- **NO START—WILL NOT CRANK—BATTERY DISCHARGED—VEHICLES BUILT BEFORE 7/18/90**
- **BATTERY—DISCHARGED—VEHICLES BUILT BEFORE 7/18/90**
- **LAMP—LUGGAGE COMPARTMENT—WILL NOT SHUT OFF—VEHICLES BUILT BEFORE 7/18/90**
- **WIRING—LUGGAGE COMPARTMENT LAMP—GROUNDED—VEHICLES BUILT BEFORE 7/18/90**

**Article No.
90-19-11**

MERCURY: 1991 CAPRI

Figure 1 - Article 90-19-11

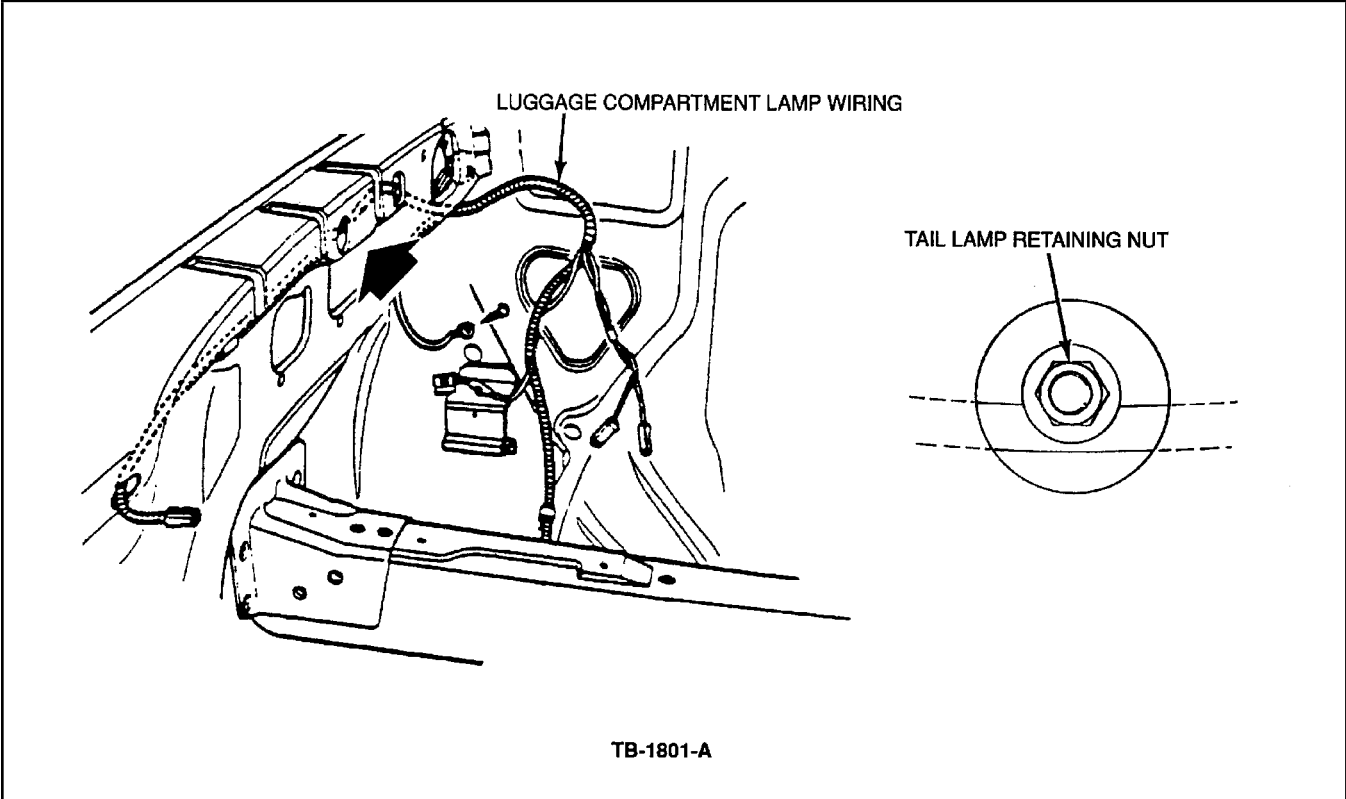
The luggage compartment courtesy lamp may not shut off when the decklid is closed. This occurs because the lamp switch wire is grounded, trapped or damaged, between the left hand side tail lamp retaining nut and the body panel. This condition also causes the battery to eventually discharge resulting in a no start condition.

1. Raise the deck lid.
2. Remove the upper back trim panel. Refer to the 1991 Capri Shop Manual, Section 45-03, for service details.
3. Using a shop light, inspect the courtesy lamp switch wiring to see where it is trapped, Figure 1.
4. Loosen the tail lamp retaining nut and free the trapped wiring.
5. Re-tighten the retaining nut.
6. Remove the deck lid latch retaining screws and remove the latch from the body panel.
7. Disconnect the courtesy lamp switch wire from the latch.
8. Reposition the courtesy lamp switch lamp wire.
 - a. Tie a piece of string 36" (900mm long) to the wire connector.
 - b. Pull the wire toward the left side of the body enough to clear the upper back panel.
 - c. Leave the string in the upper back panel to assist in reassembly.

NOTE
MAKE SURE THE DECK LID LATCH OPERATING ROD IS CONNECTED TO THE LATCH BEFORE INSTALLING THE LATCH TO THE BODY.
